Title: Cavalon (Rotorhead III) & MTO2017 Pitch Trim Pressure Correction		
AG-SB-2019-02-B-EN		Compliance Category:
Applicability		A - MANDATORY B - RECOMMENDED C - OPTIONAL
Aircraft type & model: Cavalon & MTO2017 with Rotorhead III	Affected Serial number(s): All Cavalon from V00349 to V00405 & all MTO2017 to M01810 (Rotorhead III)	
The maintenance manual to be referenced is this stated or subsequent issue.		As per AutoGyro website
This form is the response from AutoGyro GmbH either against a problem found in the product in service requiring a containment or rectification action, or as service information for aircraft modification incorporation. For help, contact AutoGyro on 49(0)5121 88056-00, or email airworthiness@auto-gyro.com .

(Pic.1)

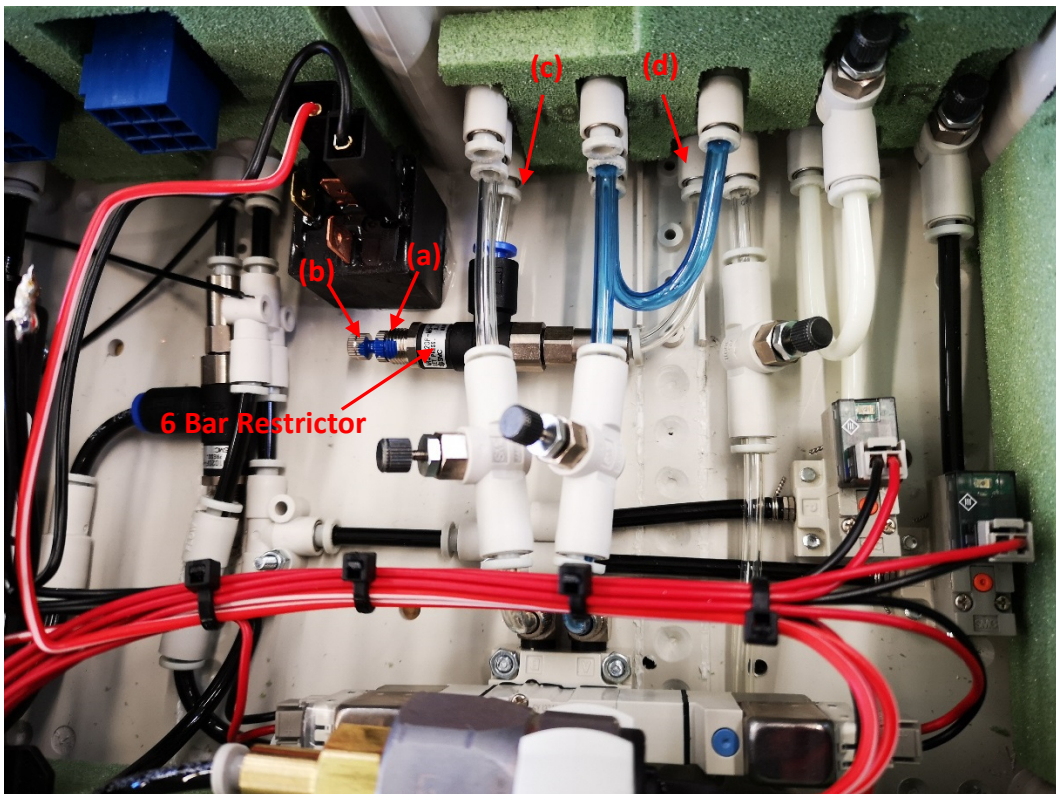
1. Remove the upper pneumatic connection (clear hose) of the brake/trim cylinder and attach a manometer with a non-return valve (Pic.1)
2. Unhook the rotor bag from the nose and ensure the rotor is able to pitch rearwards under control (a second person holding the bag chord).
3. Switch the flight/brake switch to flight, ensure the propeller is clear of obstruction and turn on the ignition.
4. Apply nose up trim by moving the 4-way switch on the top of the stick to the rear.
5. Note the maximum pressure reading on the manometer. If it is 8 bar then no further action is required. Reconnect the upper brake/trim cylinder pneumatic hose and mark with mechanic paint.
6. If the pressure is more than 0.25 bar less than that displayed in the cockpit then carry out steps 7-13:

(Pic.2)

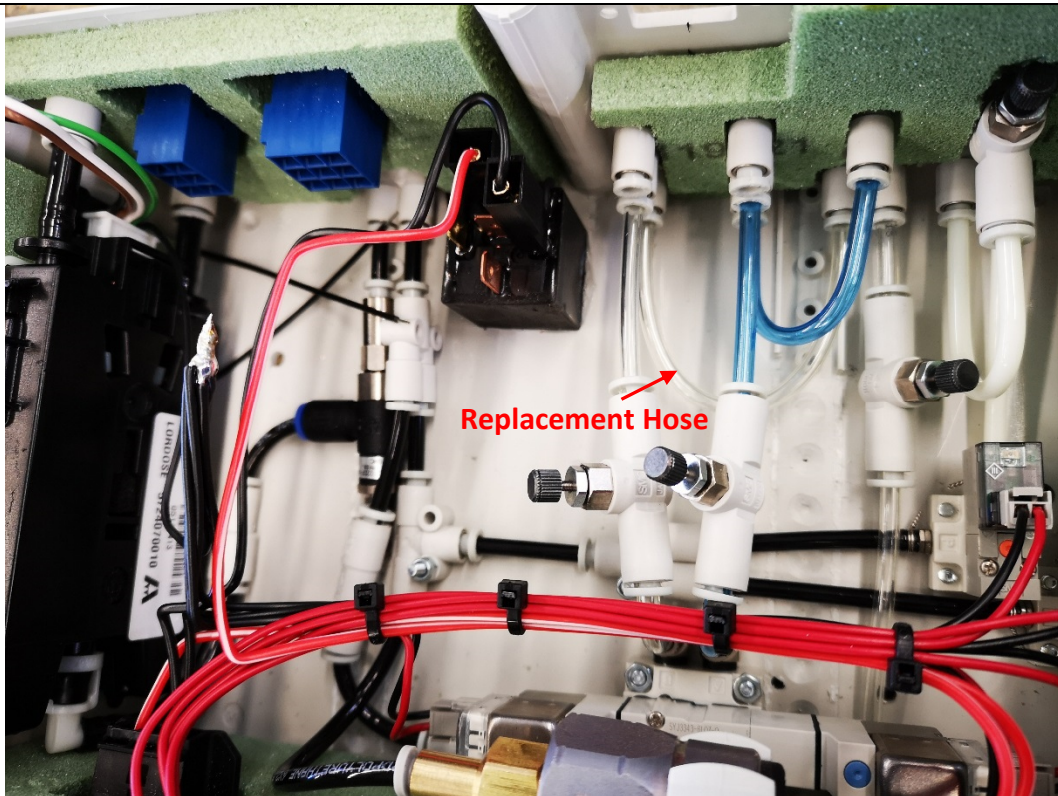
7. Gain access to the 6 bar pressure restrictor (pic.2) by removing the cover of the pneumatic box (in the nose area behind the cockpit of the Cavalon 915, behind the engine bay firewall in the Cavalon 914, or in the nose compartment of the MTO2017 – 6 screws).
WARNING: If the box has the heating option fitted then the elements are attached to the lid and must be disconnected from the box at the black 3 pin connector.

8. **Either:** release the lock-nut of the adjustment knob of the restrictor (a) and screw the adjustment knob (b) in until 8 bar can be obtained in steps 1-5 above. Re-lock the lock-nut and mark with mechanic paint.

9. **Or the preferred solution:** remove the restrictor and connecting hoses at points (c) and (d) (pic.2) and replace with a single piece of clear pneumatic hose of approx. 130mm length (pic.3).
